**LOCAL HISTORIC DISTRICT:** Dilworth

**PROPERTY ADDRESS:** 708 Mt. Vernon Avenue

**SUMMARY OF REQUEST:** Porch column addition

# Charlotte Historic District Commission - Case 2015-028

Front Porch Column Sizes

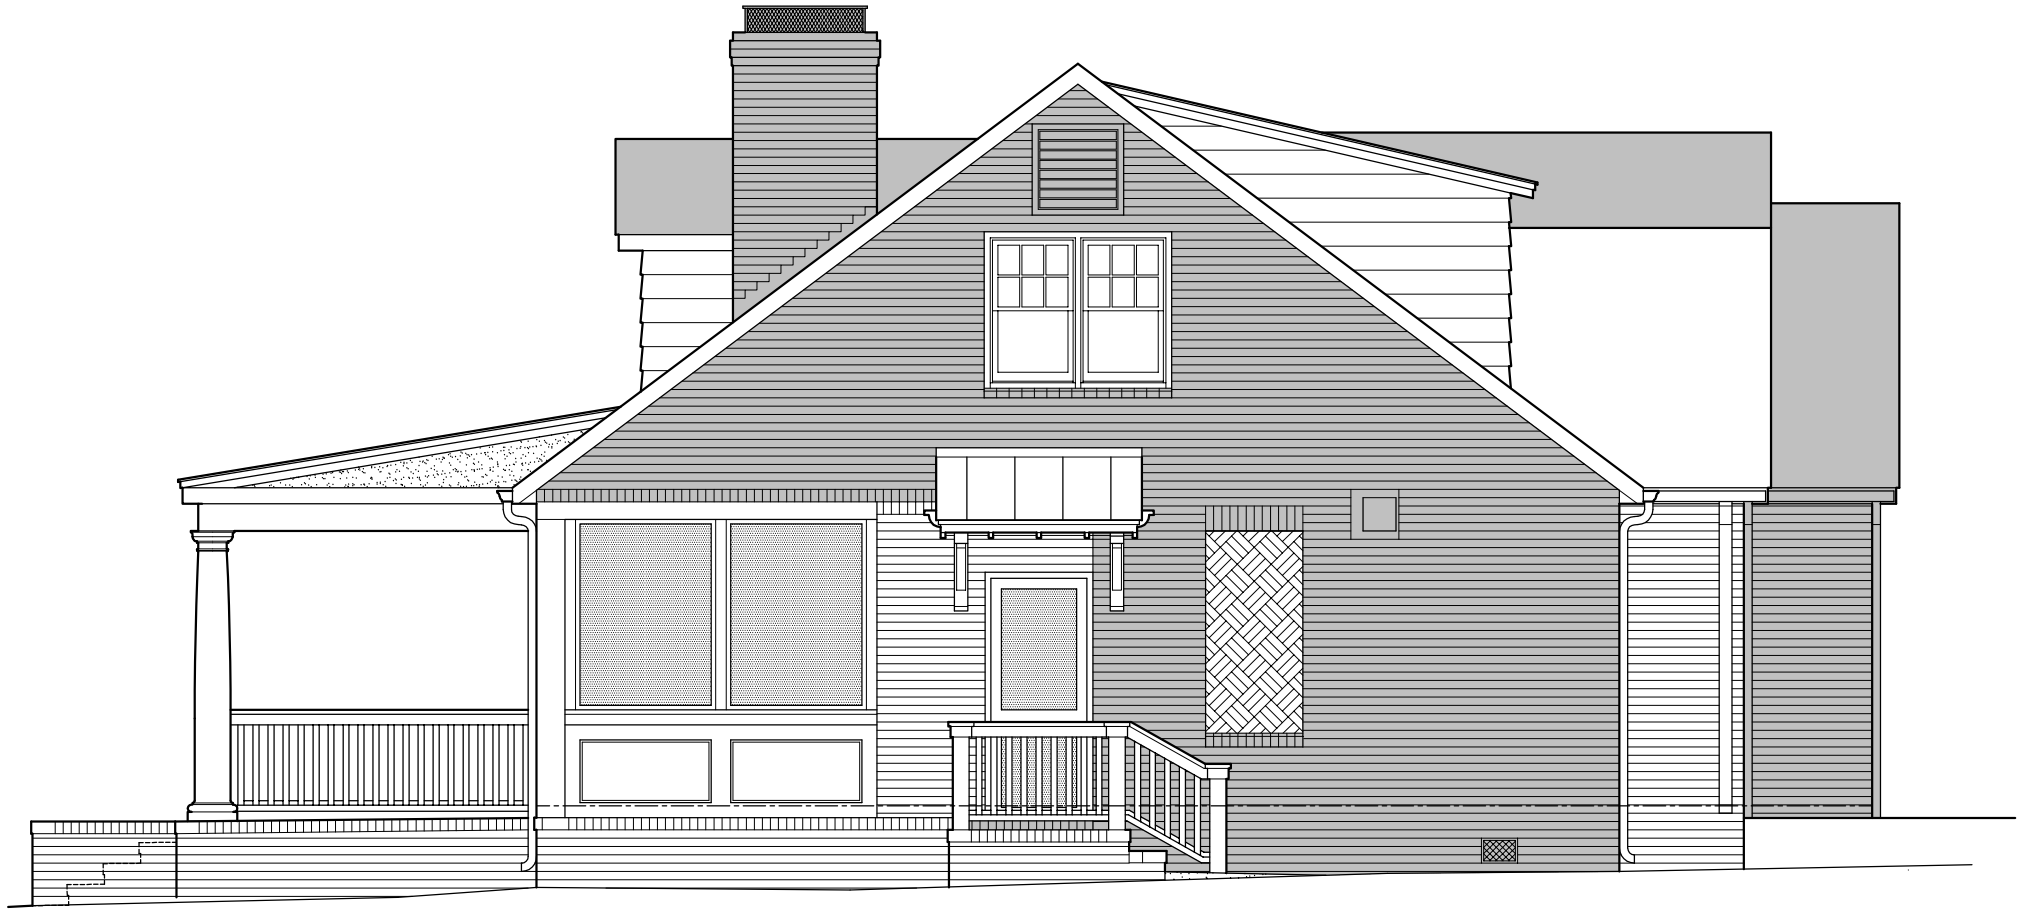
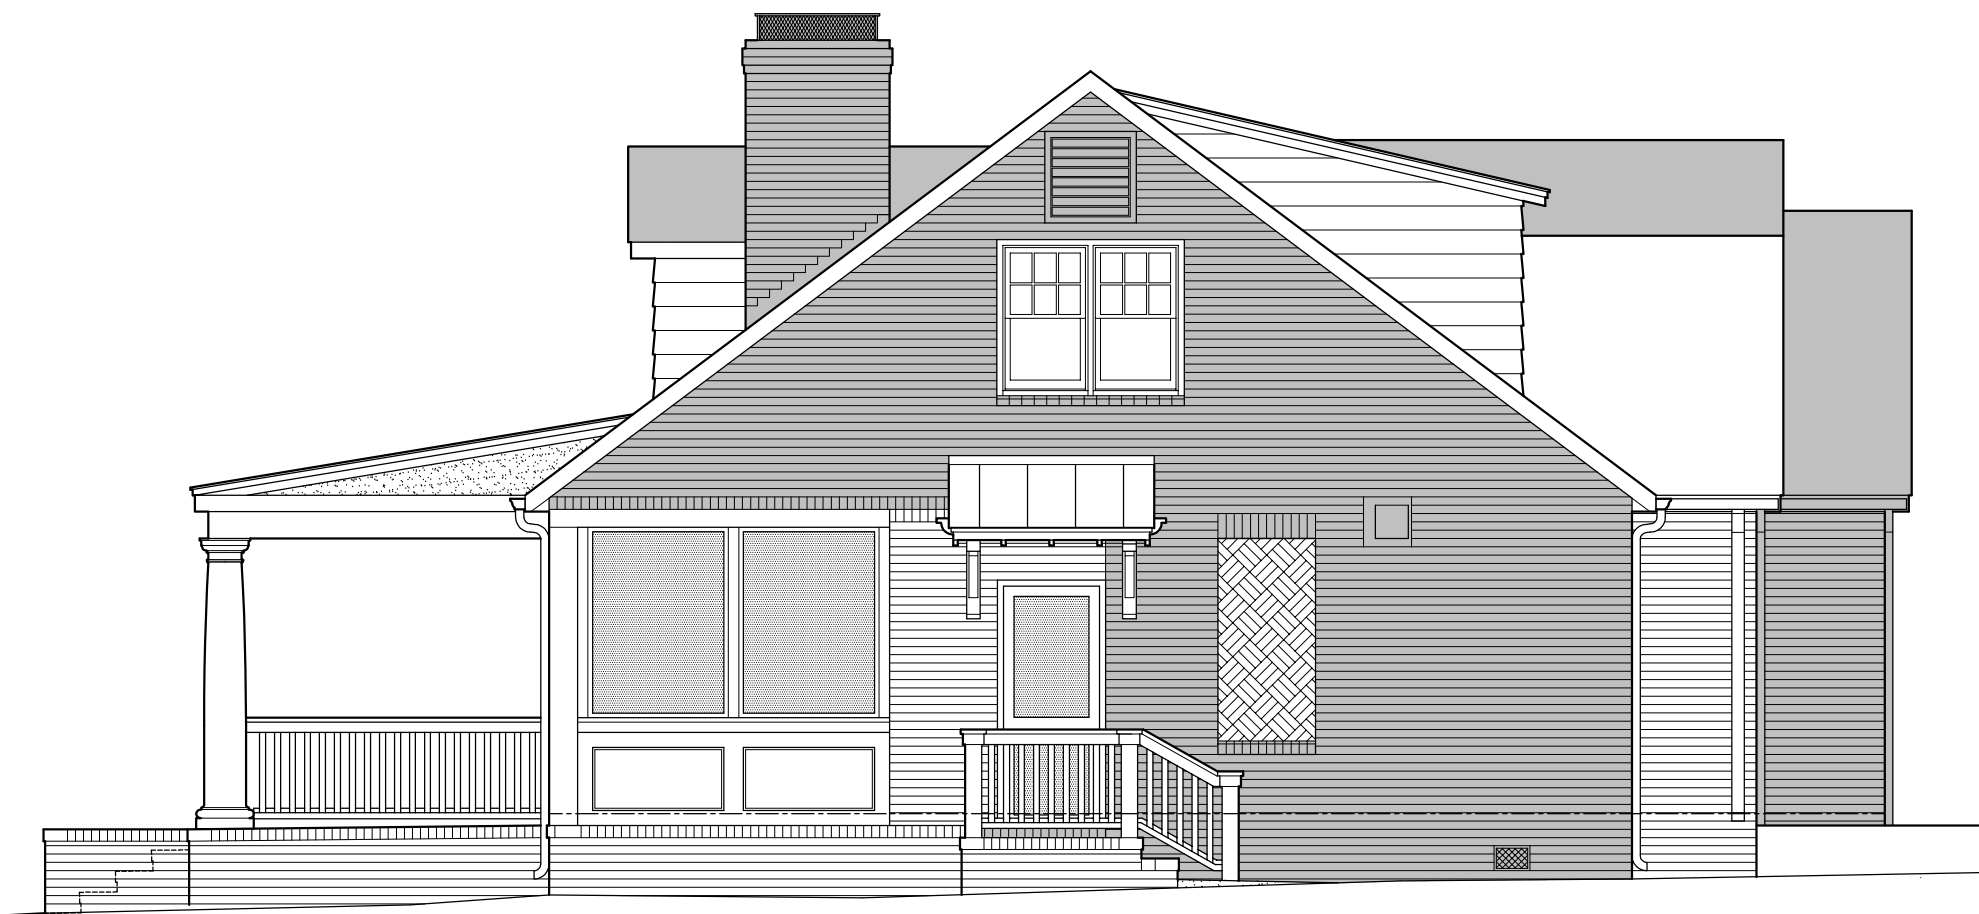
The proposal is the addition of a front porch and wood columns. The proposed dimension of the columns is approximately 8'  $\frac{3}{4}$ " by 14". The HDC recommended approval if the columns were 10" to 12" in diameter. The applicant is seeking approval for 14" columns.

For a Tuscan Order Column, (column diameter at base) x (7) = total column height.

$$(12'') \times (7) = 7'-0''$$

$$(14'') \times (7) = 8'-2''$$

Our total column height is 8'-0 3/4".

A 14" diameter column is much closer to Tuscan Order Column proportions than a 12" diameter column.
